**Re : Response to Departments' Comments**  
**Proposed Residential Development (House) and Minor Relaxation of**  
**Plot Ratio Restriction in "Residential (Group D)" Zone at**  
**Various Lots in D.D.94, Hang Tau Tai Po, Kwu Tung South, Sheung Shui**

**Proposed Residential Development (Houses) and Minor Relaxation of Plot Ratio Restriction at Various Lots in D.D. 94, Hang Tau Tai Po, Kwu Tong South, Sheung Shui, New Territories (Application No. A/NE-KTS/525)**  
**Submission of Sewerage Impact Assessment (SIA) Report**

<b><u>Comments from Environmental Protection Department and Drainage Services Department attached in Planning Department's Email</u></b>	
<b>Date: 16 June 2023</b> <b>Report Ref.: R8752_V1.0</b>	
<b>Comment</b>	<b>Response</b>
<b>Comments from Director of Environmental Protection (Contact Person: Ms. Felix TAI; Tel.: 2835 1845)</b>	
SIA

## **SEWERAGE AND DRAINAGE IMPACT ASSESSMENT**

**Figure: 2**

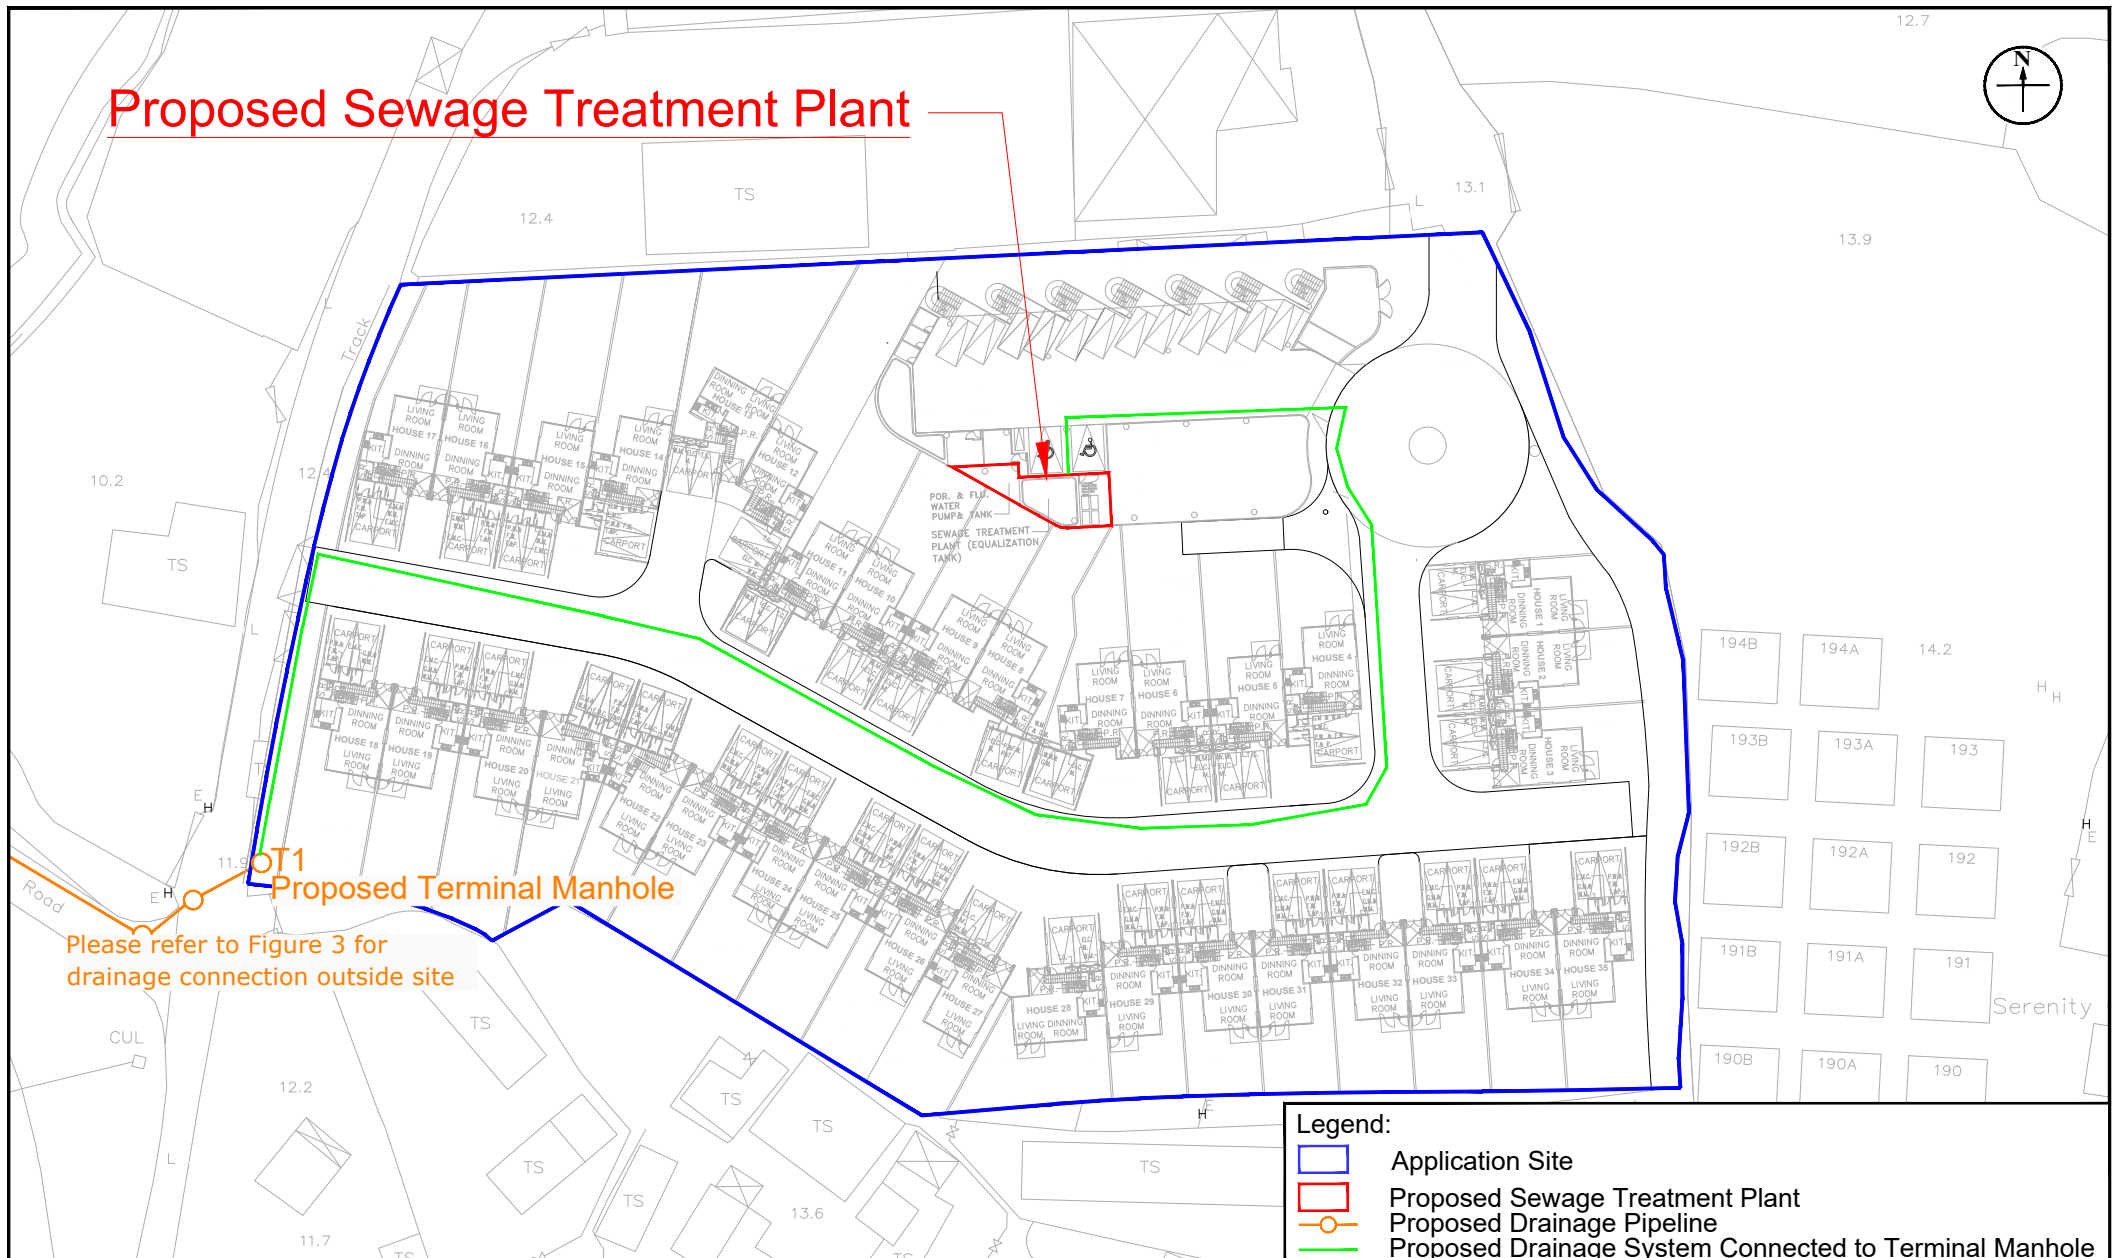
(1) Section 2.5.3 – Please provide the layout (showing the footprint) of the proposed STP for reference.	Figure 2 shows the location and layout of proposed STP which is nearby the main entrance on northern side.

(3) Please advise the discharge location and standard of the treated effluent for reference.	The discharge location was shown in Figure 2 and the proposed STP will be designed in accordance with the requirement in the "Guideline for the Design of Small Treatment Plants" issued by EPD. The standard is described under Section 2.5.7.

- 2.5.3 Membrane bioreactor **with ultra-filtration** (MBR) is recommended to achieve required effluent discharge standard and sludge dewatering system will be provided and designed in accordance with the requirement in the "Guidelines for the Design of Small Sewage Treatments Plants" issued by EPD. **Figure 2 shows the location of the proposed STP and the proposed discharge location. The project proponent will be responsible for the implementation and maintenance of the proposed private STP.**

**Appendix 3      Detailed Drainage Analysis**

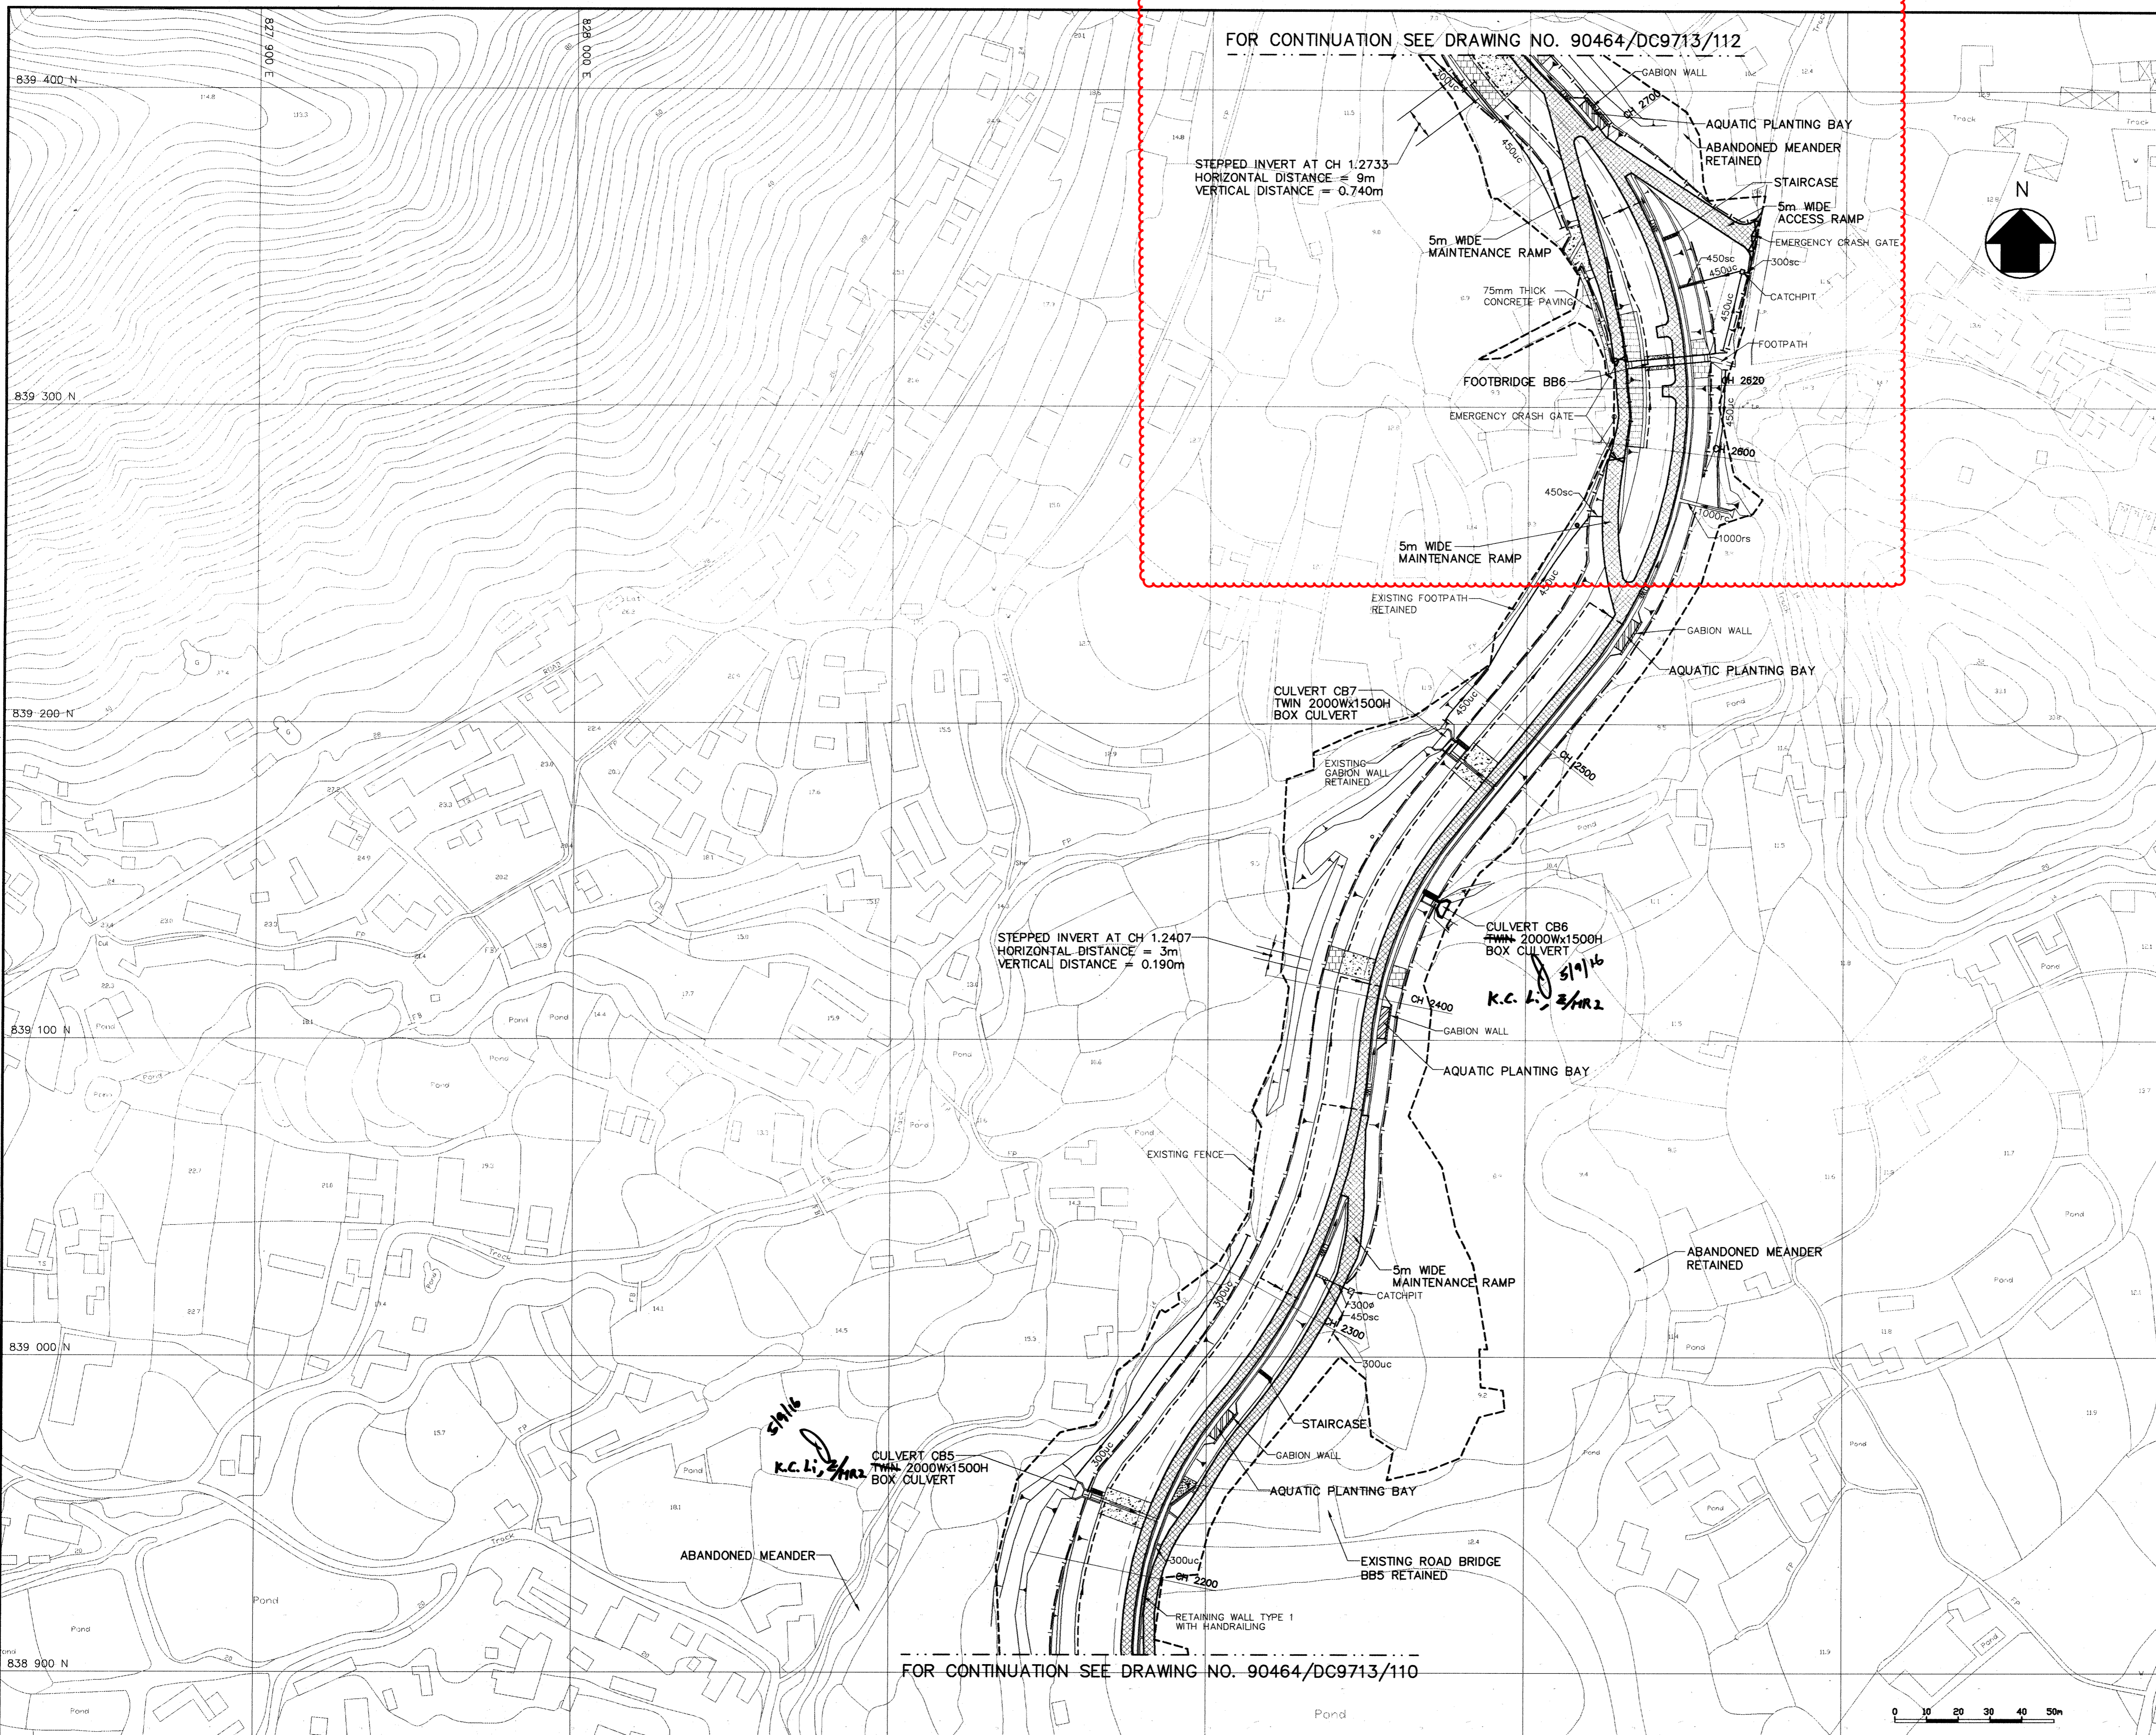
<b><u>Comments from Environmental Protection Department and Drainage Services Department attached in Planning Department's Email</u></b>	
<b>Date: 16 June 2023</b> <b>Report Ref.: R8752_V1.0</b>	
<b>Comment</b>	<b>Response</b>
impact. Please also evaluate the surface runoff before and after the proposed development for comparison.	As the Application Site will be provided at least 20% green coverage, the surface runoff will in fact decrease after development. The comparison calculation was shown in Table 1 of Appendix 2.

Runoff [2] represents the situation in Mid 21st Century (11.1%)

Runoff [3] represents the situation in Late 21st Century (16%)
